Planning Panels Victoria

Latrobe Planning Scheme Amendment C131latr Review of Flooding Controls

Figure 1: Municipal wide map displaying proposed flood overlay changes.

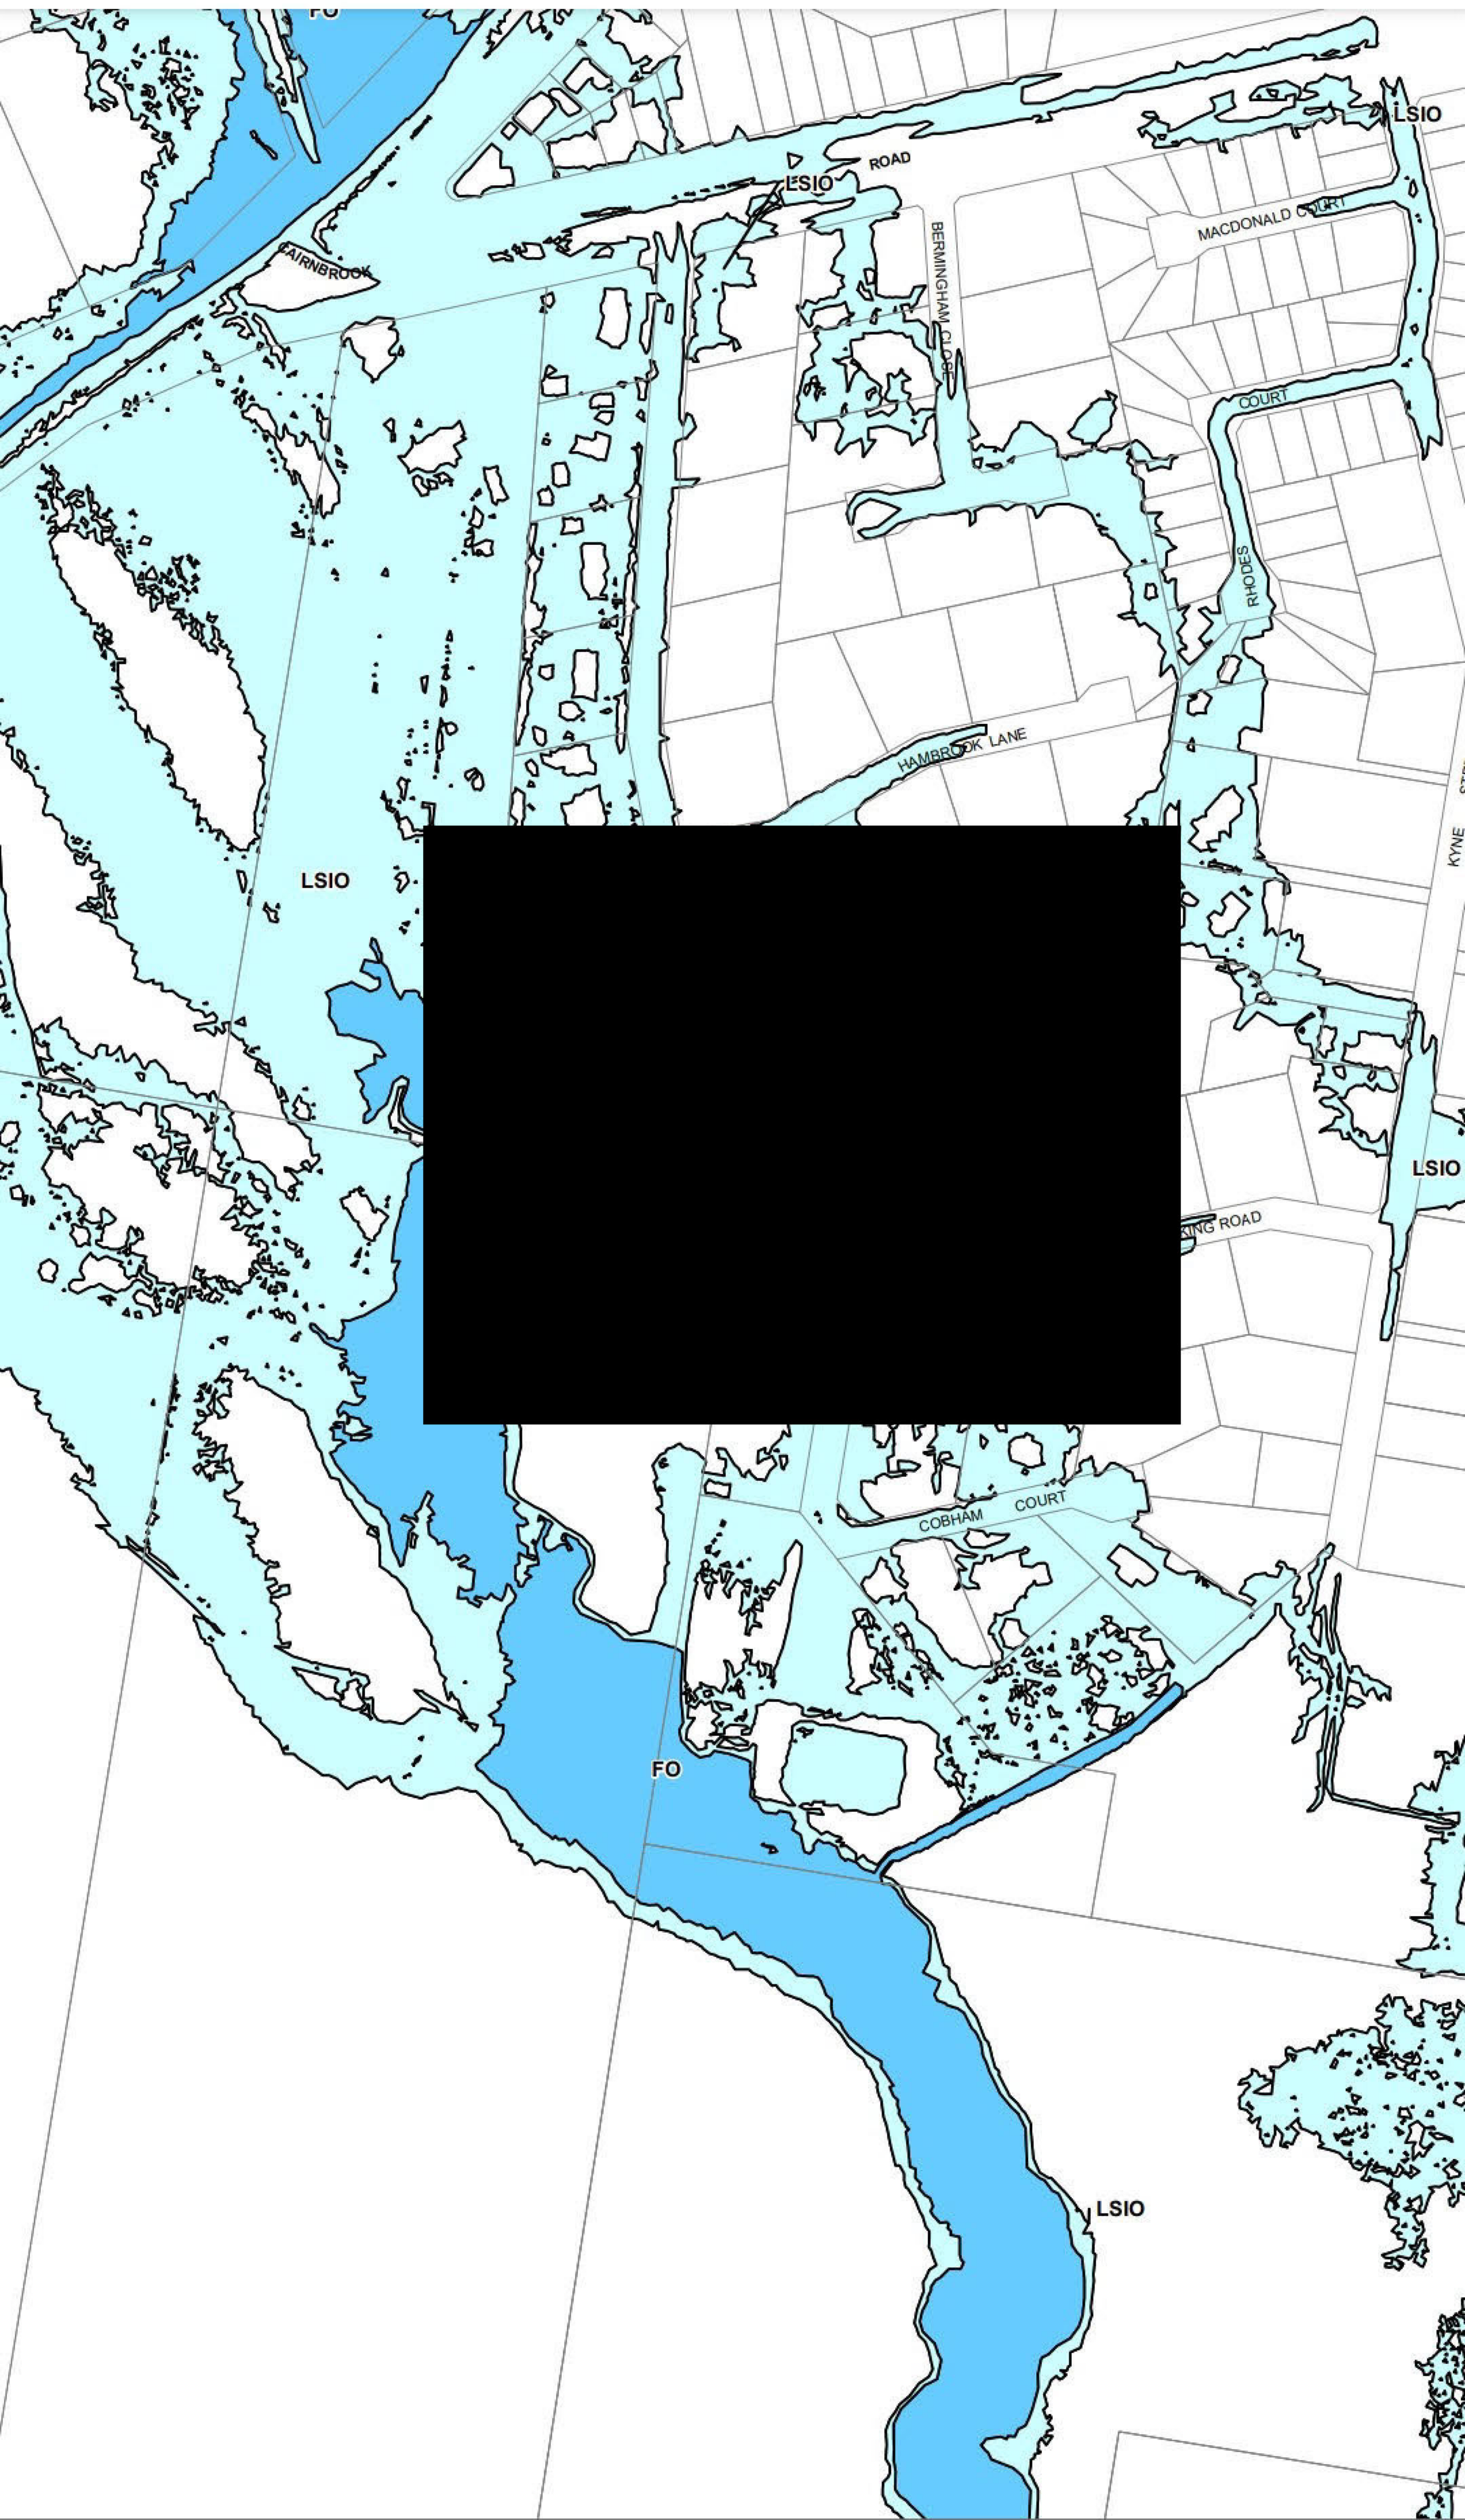
I have reviewed the LSIO map provided around my property [REDACTED] and believe it to be inaccurate and not up to date. We have only recently built and developed in the past year, and strongly disagree with the proposed amendment due to inaccuracy. Also I would like to know why amendment shows most of our block with LSIO, but area directly [REDACTED] is lower than our land and remains largely unchanged.

I have attached a screenshot and marked my property with a red circle. I would love to discuss further and happy to meet with council representative to discuss.

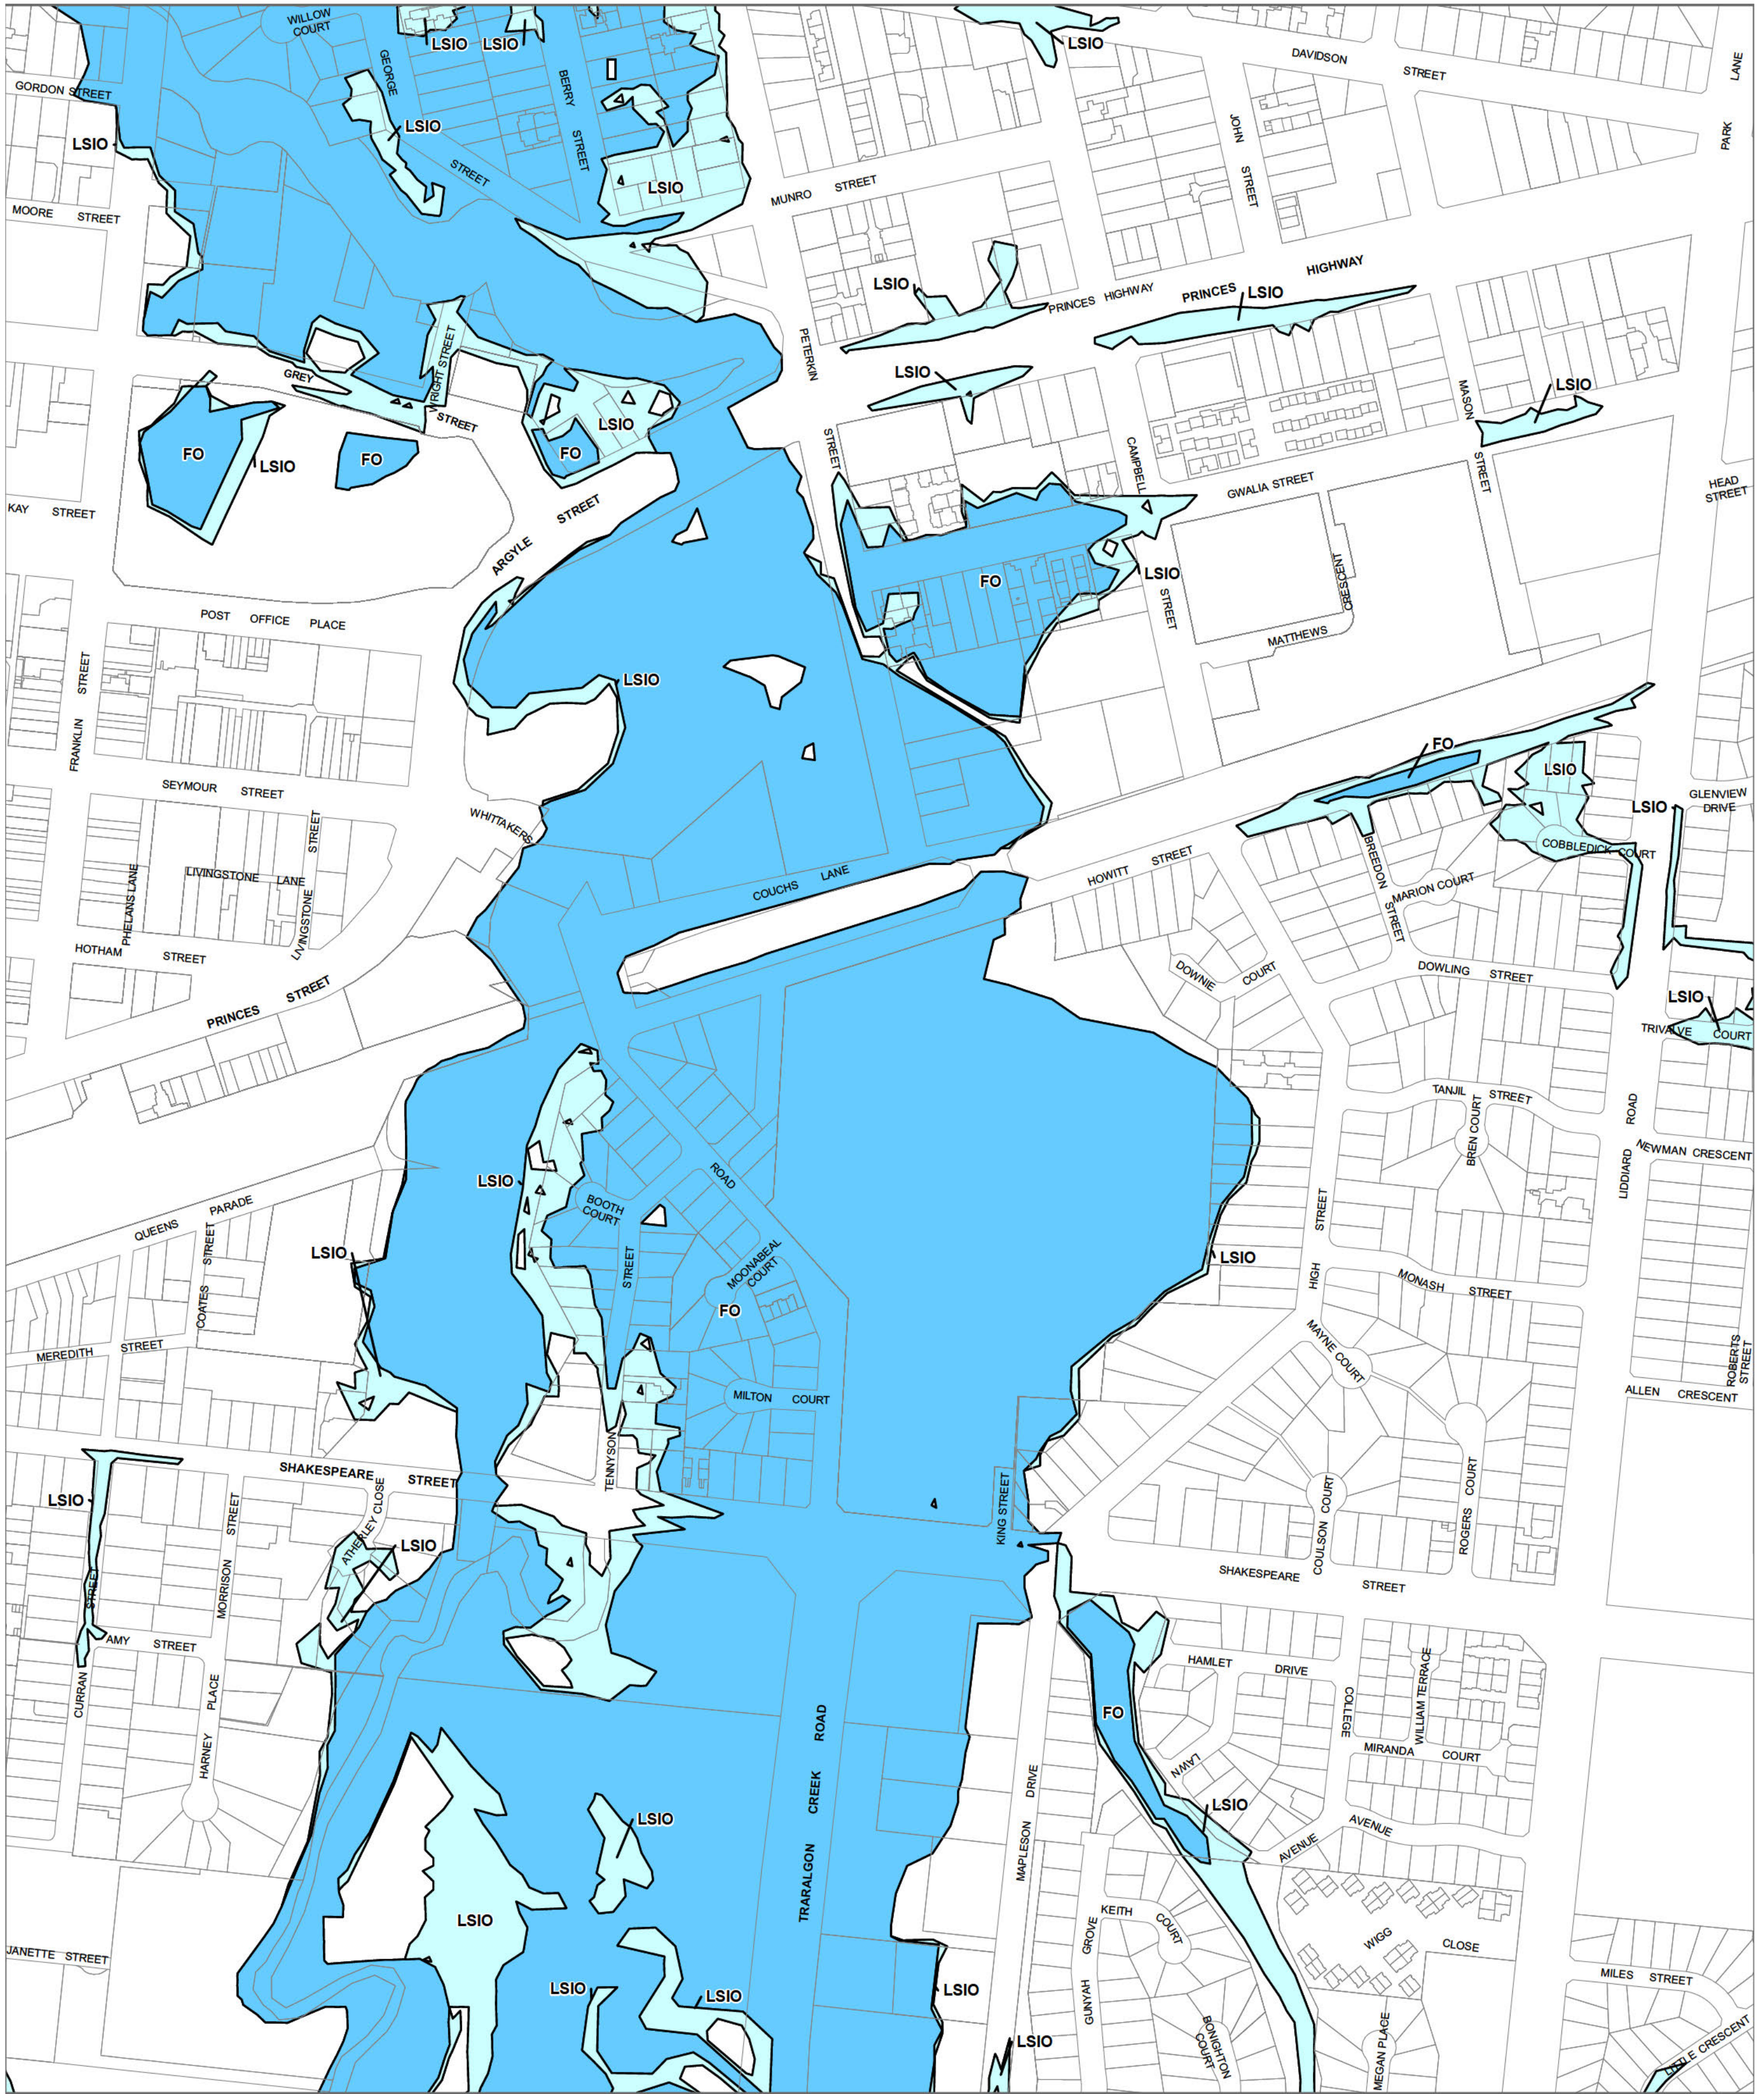
The Latrobe planning scheme amendment C131 proposes to include [REDACTED] in a new flood overlay. See attached Proposed Flood Overlay and Current Flood Overlay.

This proposed flood overlay will affect the value of my owner's corporation insurance as well as property values, it may also mean that the owner's corporation and individual owners in the complex are unable to insure.

1. I object to the proposed amendment C131 and specifically planning scheme maps 56LSIO-FO, particularly as I have been the owner of unit [REDACTED] [REDACTED] since 2005 and cannot recall any times water has entered the grounds, no damage or impact to this property or others (in this unit complex) has been sustained during any flood events in Traralgon during this time. This includes the most recent major floods in June 2021 whereby an all-time record Traralgon Creek flood level was observed.
2. I propose that amendment C131 including planning scheme maps 56LSIO-FO be updated to exclude [REDACTED] from the flood overlay.

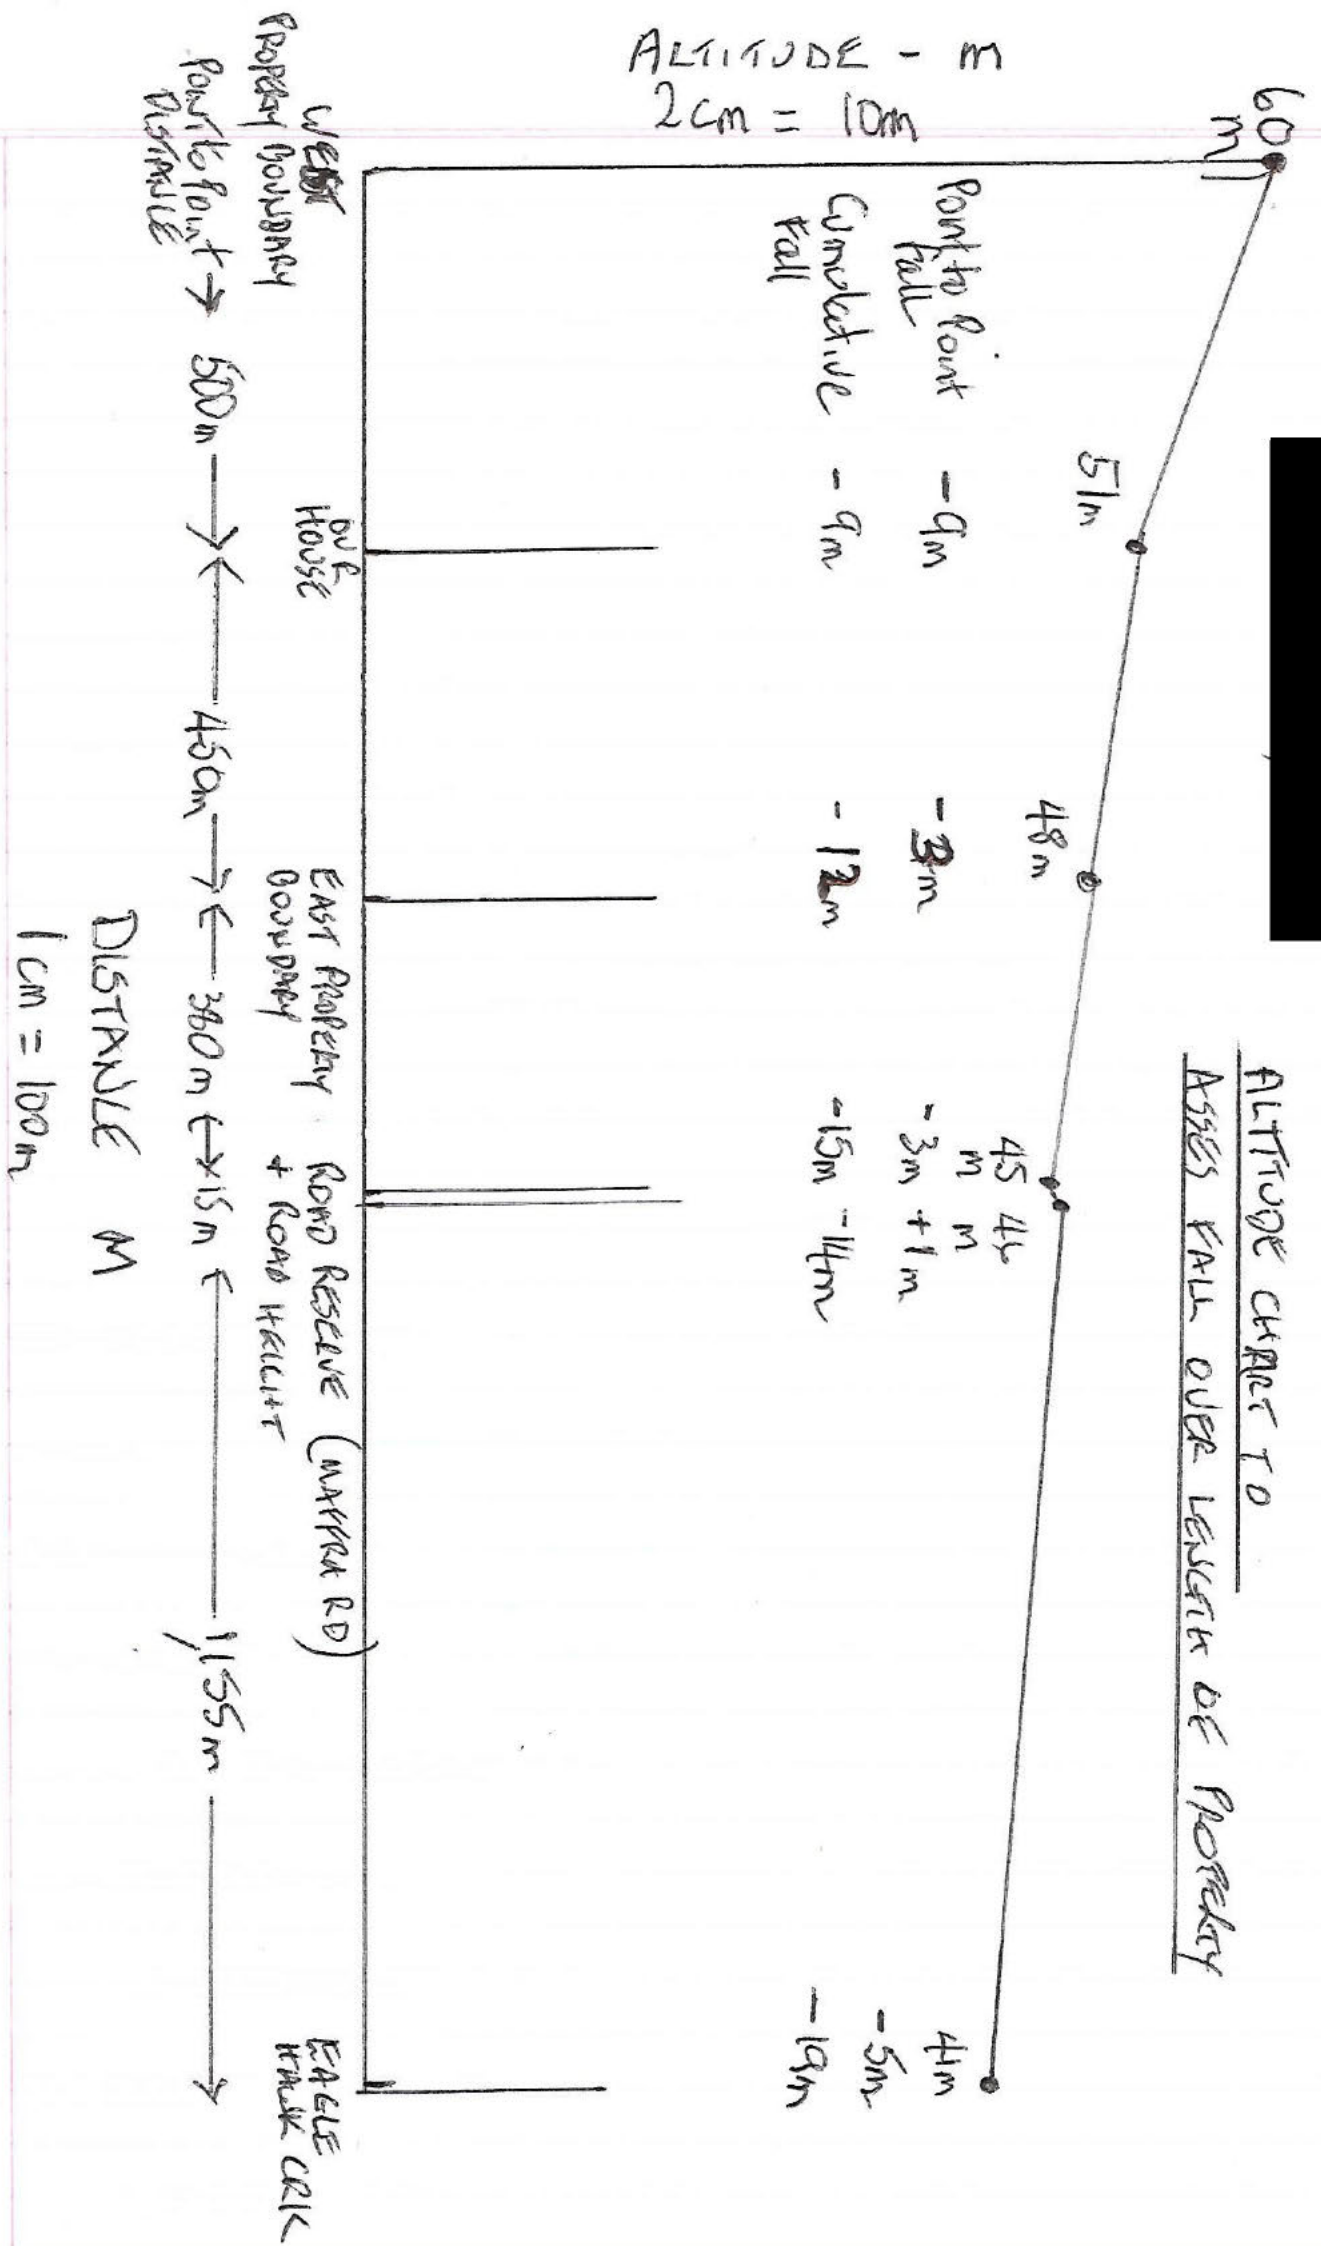
I have attached a sketch of all the above distances and altitudes for your information

It is for these reasons that I do not consider my property to be at risk of inundation, and request that it not be included in the LSI overlay.
